# Zoning Challenge and Appeal Form (for approved applications)

BIS Job Number 122975995

ZRD2: Zoning Challenge with response

RE: Zoning Challenge  
249 East 62<sup>nd</sup> Street  
Block 1417, Lot: 22  
Job No: 122975995

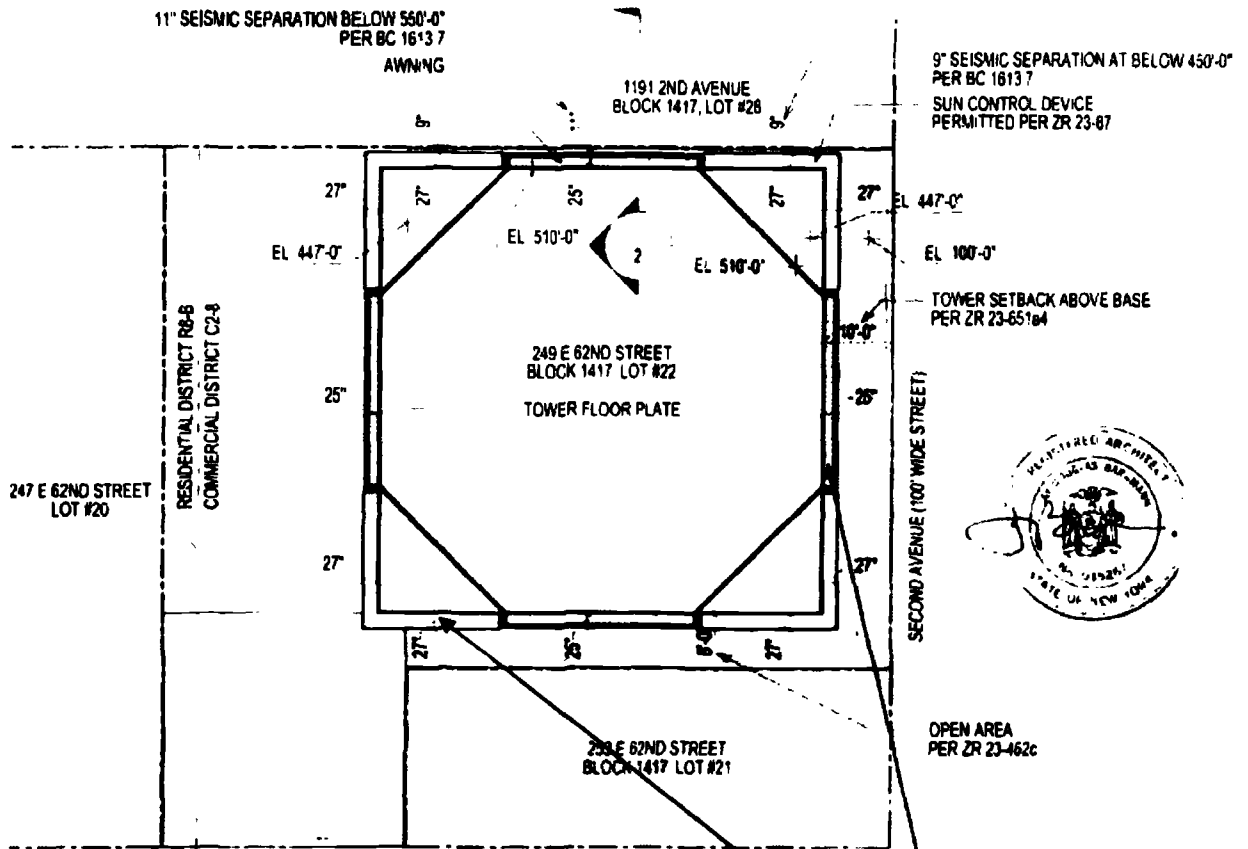
Section 77-22 instructs how to calculate the allowable FAR of a lot split by a zoning district:

Each such #floor area ratio# shall be multiplied by the percentage of the #zoning lot# to which such #floor area ratio# applies. The sum of the products thus obtained shall be the adjusted maximum #floor area ratio# applicable to such #zoning lot#.

The zoning lot is 8,765 SF. The C2-8 portion is 8,263 SF. The R8B portion is 502 SF. The following table shows the split lot calculation instructed by 77-22.

As was determined by Section 1 of this analysis, the building proposed is 103,876 SF of zoning floor area, which means that the building as proposed is overbuilt by 2,712 SF. These calculations were never shown on the ZD1, which incorrectly asserts that 12 FAR is allowed and the building proposed is 12 FAR.

This portion of this challenge is denied. The application records indicate a proposed FAR is of 11.54. The applicant will be advised to correct the ZDI diagram to reflect the proposed FAR.

Reproduction of perspective view of building with shading devices from ZRD1 51136

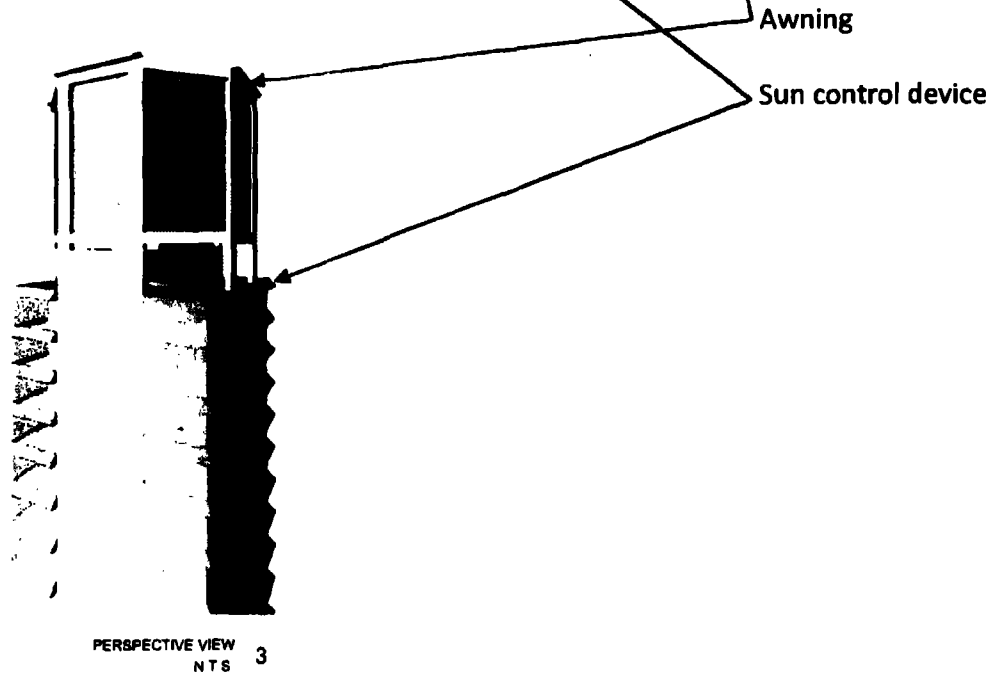
ZRD1 51136 of 9/5/2017 concerns the sun shading devices planned for the upper floors of the building. The following show a plan and perspective view taken from that ZRD1:

At issue is the northern lot line. Regarding side lots, ZR 23-462 (c) states:

"If any open area extending along a #side lot line# is provided at any level, it shall have a minimum width of eight feet"

No zoning variance was granted. The determination request, a code variance, to accept the proposed sun shading devices extending beyond the exterior north building wall in excess of 12 inches was approved with conditions pursuant to BC 705.2(2) only. This variance from BC code was issued under the Commissioner's authority AC 28-103. No open area is proposed, therefore no side yard requirement is created. Therefore, this portion of the Zoning Challenge is denied.

*Second Avenue elevation with three foot side yard identified. The awning and sun control devices are permitted obstructions and so not shown.*

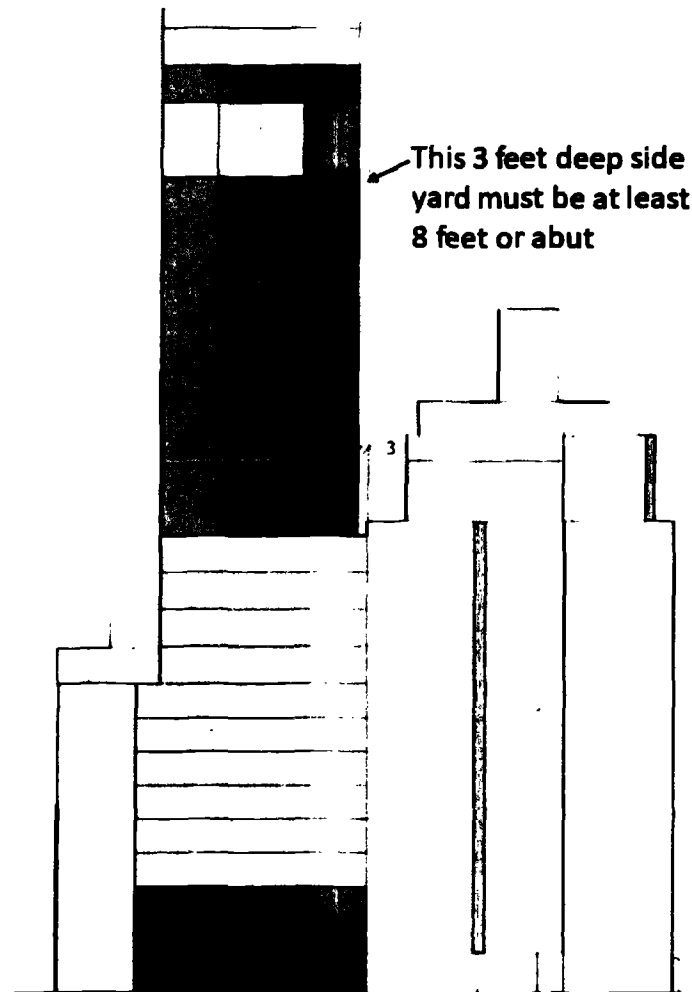
There is an open area of three feet between the building wall of the new building and the lot line. If this space were eight feet, it would comply. If this space were 11 inches (the required seismic separation distance), it would also comply since ZR12-10 states that abutting buildings do not include: "separations required for seismic load as set forth in the New York City Building Code." But a three foot separation, even when up to 11 inches of that is required seismic separation distance, is not allowed under 23-462 (c) and does not comply with the side yard requirement for this district.

Indeed, ZRD1 51136 states that the solar projections are permitted obstructions in a side yard under 23-44. This is true, they are permitted obstructions in a side yard: a side yard that is too small to comply with 23-462 (c).

ZRD1 51136 involves a complex argument for two simple questions: How big is the side yard? Three feet. Does the side yard comply? No. The arguments contained in ZRD1 51136 regarding the building code are NOT contrary to the requirements of the zoning, since an eight-foot separation would have complied.

*Approximate building massing annotated by use*

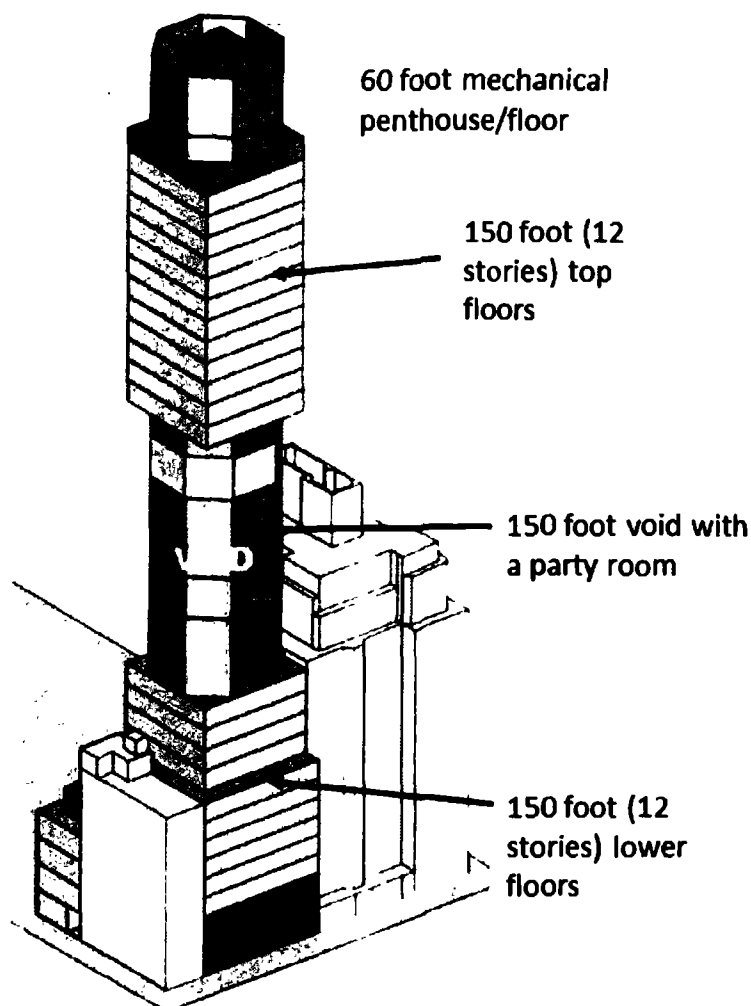
We see the mechanical portion of the proposed building in gray. At issue is the space that starts at approximately 148 feet and extends to 300 feet. This space is mostly empty, but also includes an amenity room. Excluding the cellar, the amount of the building's gross floor area devoted to mechanicals and other exempt spaces is 25%.<sup>1</sup> Many of these mechanical void floors have very large floor-to-floor heights so that the volume of this building devoted to mechanicals and voids is nearly 31% of the building's mass. This percentage goes up to 33% if we consider the area not open to the sky that is also inscribed by perimeter walls.

This is an exceptional amount of space devoted to accessory building mechanicals and other exempt spaces. Clearly, much of this space, its configuration and floor-to-floor height serves another purpose, which is to provide extra height to the building's upper floors, yet the DOB still found the area exempt from floor area

Application records indicate, the middle portion of the building (levels 13-16), referred to by the Challenger as an "inter-building void", contains a structural outrigger(between levels 13 and 14), one fully enclosed mechanical floor level (level 16), one amenity floor level (level 15) and two roofed terrace levels (levels 13 and 14). Levels 13 and 14 are noted as "mechanical roofs" with no occupied space.

Per the definition of floor area in Section 12-10 (Definitions), the proposed mechanical floor (level 16) with floor space used for mechanical equipment shall not be included in floor area. The height of the mechanical floors is not governed by the Zoning Resolution. In addition, the proposed roofed terraces (Levels 13 and 14) are not considered floor area. Therefore, this portion of the Zoning Challenge is denied.

SITE PLAN DIAGRAM  
SCALE 1" = 20' 01

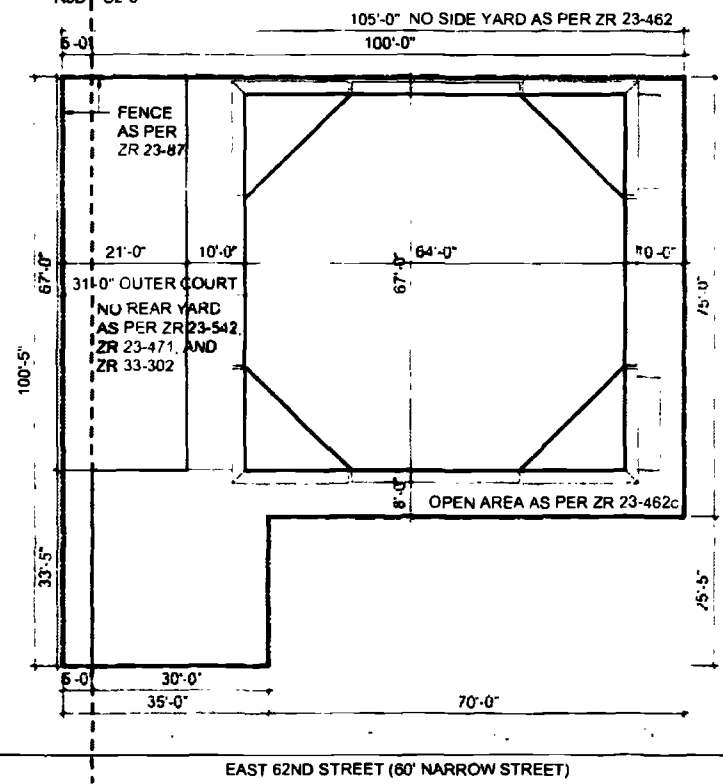
The northern side shows the “building” extending to the lot line (note the 67’ measure goes all the way to the northern lot line.) Effectively, the projections count as an exterior building wall for the purposes of the side yard. On the other three walls, the projections do not count as an exterior building wall. Had the other three walls used the standard described by ZRD1 51136, the tower would be 69 feet by 69 feet, or 4,761 SF. A tower of this size would be 54.3% of the zoning lot, which would mean that the tower is too large under 23-651, which limits towers on lots of this size to no more than 50% of the zoning lot.

Further, ZR 23-651 requires towers to be setback 10 feet from a wide streetline. It is only 10 feet from the exterior building wall, not from the sun-shading devices that function as the exterior building wall on the north side. The applicant is mixing and matching standards on the same building, selecting whichever standard benefits them most. The applicant’s intention to mix and match standards is not clear in the ZRD1; there is a difference in the representation of the exterior building wall when compared to the ZD1. In the ZRD1, the wall is shown to the edge of the awning on all sides. On the ZD1 it is only shown to the edge of the awning on the north side.

Per Department records, the sun shading devices were excluded in the lot coverage calculation (Sheet Z-001.00 Zoning Diagrams). Application records indicate the following:

North wall: Per ZRD1 (51136), the projections on the north wall are part of building wall and shall be considered lot coverage. (Therefore there is no open area.) The applicant shall confirm these are included in lot tower coverage.

East Wall: The sunshade devices on the east wall project into the required 10-foot front setback per 23-65 (Tower). Per ZR Section 23-62, they are not permitted obstructions in a required front setback of tower regulations (ZR 23-65). Therefore, the proposed sun shading devices are not permitted (on the east facade) within 10 foot required front setback. This portion of the challenge is accepted and appropriate measures will be taken.

South wall: The sunshade devices on the south wall project into the 8-foot wide open area (side yard) along the side lot line; And they are considered permitted obstructions in this side yard per Section 23-44 (Permitted Obstructions in Required Yards or Rear Yard Equivalents); In addition, the obstructions permitted pursuant to Section 23-44 (Permitted Obstructions in Required Yards or Rear Yard Equivalents) shall not be included in #lot coverage# per ZR 12-10 Definition of Lot coverage.

West Wall: The sunshade devices on the west wall project partially within a 31-foot wide outer court. However, they are considered permitted obstructions per ZR Section 23-87 (Permitted Obstructions in Courts). However, they are not exempt from lot coverage per ZR 12-10 Definition of lot coverage. The applicant shall confirm these are included in lot tower coverage.
